Atmos. Meas. Tech. Discuss., 3, C1818-C1853, 2010

Interactive comment on "Water droplet calibration of a cloud droplet probe and in-flight performance in liquid, ice and mixed-phase clouds during ARCPAC" by S. Lance et al.

S. Lance et al.

Fig. 1. (S1) Optical Schematic of the CDP

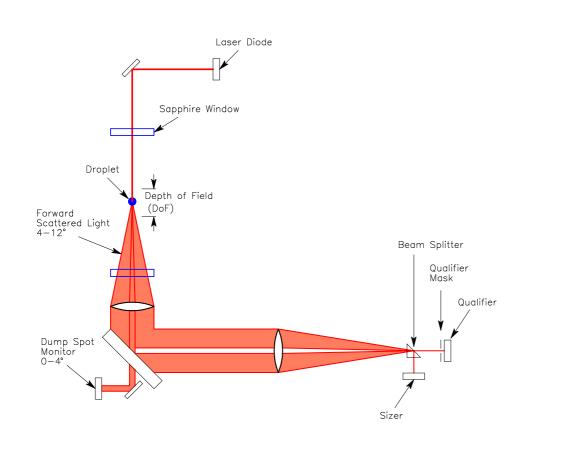
"The comments below don't necessarily reflect this, but I think the importance that the qualifier and sizer signals take on later in the paper require a lot more careful explanation of how this works in the instrument. A figure illustrating this would go a long way to helping the reader out."

"3141, 5-6: I'm still a bit unclear how this works. This sentence makes it sound like the total light scattered is then divided between the qualifier and sizer, whereas later I infer that at least the intensity as a function of scattering angle information must be preserved. I think a picture would help this out immensely. I also think it's such an important part of what happens later that you should take the time to explain this well."

The basic operation of the two detectors (qualifier and sizer) are essentially the same as in the CAS and the FSSP, which have been written about in detail in many papers (e.g. Baumgardner et al, 2001; Burnet and Brenguier, 2002; Hovenac and Lock, 1993). However, since the optical geometry is central to our discussion of coincidence errors, and since it seems that there was confusion about certain aspects of this, we now add a figure to illustrate the basic optical configuration of the CDP (Figure S1).

You are correct that the scattered light is collected and split between the qualifier and sizer. It is unclear why you would infer that the intensity as a function of scattering angle is preserved, since that is not written here or elsewhere, so we cannot respond about this. To assist the reader, we now add a figure to illustrate the basic optical configuration of the CDP (Figure S1).

Fig. 2. (S2) Simulation of evaporating water droplets

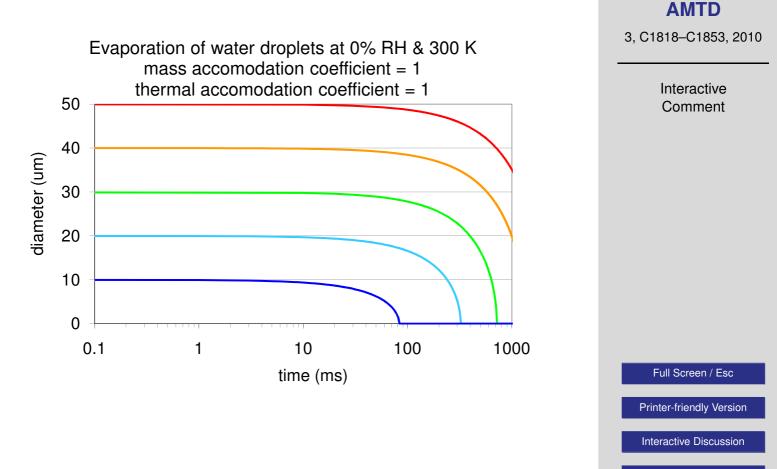
"3145, 26: might this velocity change cause a temperature of the air? if so, any chance the drop size responds to this?"

Yes, the temperature of the air increases as a result of airflow acceleration. However, the drop size is not expected to respond significantly to this increase in temperature given the short duration that the droplets are exposed to these changing conditions prior to detection (< 1 ms, given a generous 10 cm boundary layer upstream of the laser beam and an aircraft velocity of 100 m/s). Even if ram pressure heating could bring the temperature to 300K and the relative humidity to 0% (unrealistically hot and dry conditions), 10 um droplets would shrink due to evaporation by less than 1% if exposed to those conditions for 1 ms (See Figure S2).

Fig. 3. (S3) Calibrated sizer and qualifier signals as a function of position within SAQ for 22 um (top) and 12 um (bottom) droplets

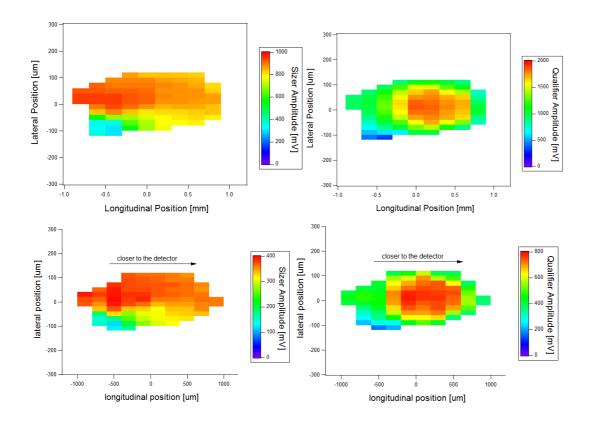
"What I'm confused by is why the calibration was done like this in the first place. Since the drops pass through lower intensity parts of the beam, isn't it necessary to calibrate based on all trajectories that will be accepted by the CDP, and not just the ones with max amplitude? Why should this 2 um shift be needed? Couldn't one just traverse the cal drops through the beam until they're rejected by the instrument and then weight each stream by its likelihood?"

The red symbols represent single droplets that have been transmitted across SAQ at the center of the DoF. We mistakenly wrote in the paper (Page 3149, Line 25) that these points represent the maximum sizer pulse amplitude, when, rather, the qualifier pulse amplitude is maximum at this location (See Figure S3). We made this mistake again, by incorrectly stating (Page 3150, Line 4) that "...the calibration using water droplets is constrained to the center of the DoF where the scattered light signal is highest..." In actuality, the scattered light signal (recorded by the sizer) is greatest at the edge of the DoF, not at the center of the DoF (again see Figure S3).

Yes, the instrument response at different locations within the sample area needs to be accounted for. The calibration method suggested by this reviewer has been implemented, with the results reported in Figure 4 of the paper (and Figure S3). We assume that all streams within SAQ are equally likely. At this point we would obtain additional calibration points for other droplet sizes (averaging the response over all positions within SAQ, as we did for 12 and 22um droplets), however the instrument has been optically modified since the date of publication. Because the average response for 12 and 22 um droplets was consistent with the response for various droplet sizes at the center of the DoF, as calibrated on two separate days (Figure S4), we believe that the reported results are sufficient for our analysis.

Fig. 4. (S4) Updated version of Figure 2 from the paper (see full caption in the text)

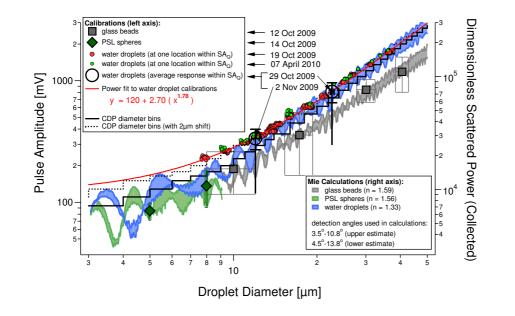
"Leads to Fig 2 issues as well - it's not clear what is supposed to agree with what (like the red symbols, the way the cal was done, shouldn't actually correspond to the blue "curve", for example). left and right axes reversed in caption? also, if units are Watts, add to axis label. I like the uncertainties for the calibration points, but they're hard to see - I'd suggest making them darker (esp. for the PSL)."

"Again, the issue of why one expects Fig 3 standard measurement data to line up along the 1:1 curve is odd - you selected only a small subset of possible trajectories and thus there's no reason to think that the CDP standard measurement is valid here. It only works as an average if you send drops along all trajectories, right?"

We now include in Figure 2 of the paper the sizer signal averaged over all positions within SAQ (Figure S4), obtained from the calibrations reported in Figure S3 (for 12 and 22 um droplets, respectively). The average response agrees well with the response reported for droplets at the center of the DoF. Again, this contradicts the statements above that we are now retracting from the paper.

Yes, the caption has the left and right axes reversed – that has been fixed. We also darken the error bars for the PSL and glass bead calibrations.

Figure S4 Caption: Figure 2 from the paper with additional water droplet calibrations added. The average sizer pulse amplitudes (as well as the standard deviation, minimum and maximum) are shown for calibrations with 12 um and 22um water droplets, respectively, over all positions within SAQ. Also shown are water droplet calibrations of various sizes near the center of the DoF on another day (about 6 months after the calibration that was originally reported in the paper). These added data illustrate that calibrations at the center of the DoF are representative of the average instrument response.

We do have reason to suspect that these observations (with droplets of various sizes transiting across the center of the DoF) are a valid representation of the average CDP response. We have now added the average CDP response for 12 and 22 um over all positions within SAQ to Figure 2 of the paper (See Figure S4).

Fig. 5. (S5) Simulated CDP response function assuming various degrees of misalignment (see

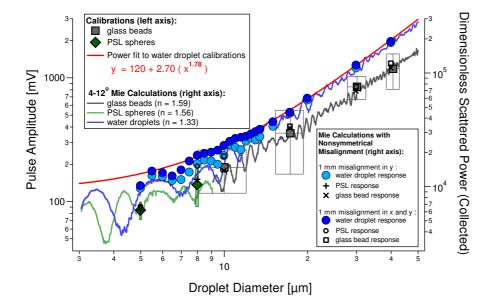
"30: I'm also very surprised by this - and I think it deserves more discussion than this. Other people have been able to reproduce this behavior in other optical instruments, and I'm assuming it's been done for the FSSP though I don't know for sure. But in any case, it must say something important about either the optical model used for the instrument or the calibration method or the instrument itself. Is there some way to address this further?"

This is a very good point – and we have spent a good deal of time attempting to address it. We calibrated another CDP in the lab and were able to reproduce Mie resonance structure. Therefore we do not believe that there is a problem with the calibration method. We have also duplicated the monotonic response with the CDP reported in this paper (Figure S4).

We speculate that the optical model is insufficient for this particular instrument due to optical misalignment (beyond the symmetrical ± 0.5 degree shift modeled). If the qualified sample area is out of alignment with the center of the laser beam, this would result

Figure S5 Caption: The calibrated response of the CDP to PSL and glass beads, and the calculated response for PSL, glass beads and water droplets assuming that all forward scattered light 4-12 degrees is collected by the sizing detector. The light blue dots show the modeled CDP response for water droplets given a 1 mm misalignment in the y-dimension (laterally across the laser, and perpendicular to the droplet trajectories). The dark blue dots similarly show the modeled CDP response for water droplet calibrations is shown for comparison. The CDP response to PSL and glass beads, given these misalignments, are also shown, and often agree well with the PSL and glass bead calibrations.

Fig. 7. (S7) Interarrival times randomly distribution between 0 and 2*tau (blue) versus a Poisson distribution (red). See full caption in text.

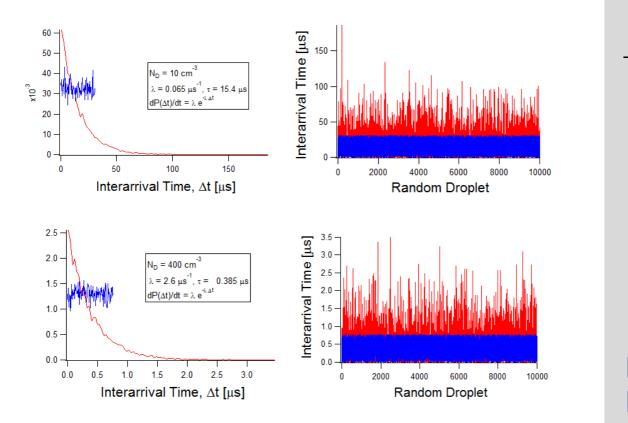
[&]quot;3153, 20: Can you explain the implications for choosing an inter-arrival distribution that's uniform and limited to 2 * tao? In the absence of any small-scale clustering, one would expect the distribution to be Poisson with mean (and standard dev) of tao, which means there's a long tail to larger tao values than you use here. Would using a more realistic distribution change the results?"

Great question! We reran the simulations (with the same input size distribution and pulse widths), but instead of using a random distribution of interarrival times between 0 and 2*tau, we used a Poisson distribution of interarrival times [Field et al, 2003].

Figure S7 shows a comparison between these interarrival time distributions. Although the probability distributions are clearly different, there was no significant change in the coincidence errors when using the Poisson distribution (Figure S8). We now briefly describe these additional simulations in the paper here.

Figure S7 Caption: Interarrival times randomly distributed between 0 and 2*tau (blue) and a Poisson distribution of interarrival times (red) for droplet concentrations of 10 cm⁻-3 (top) and 400 cm⁻-3 (bottom), respectively. Figures on the right show random sampling from each of these distributions and figures on the left show the probability distributions.
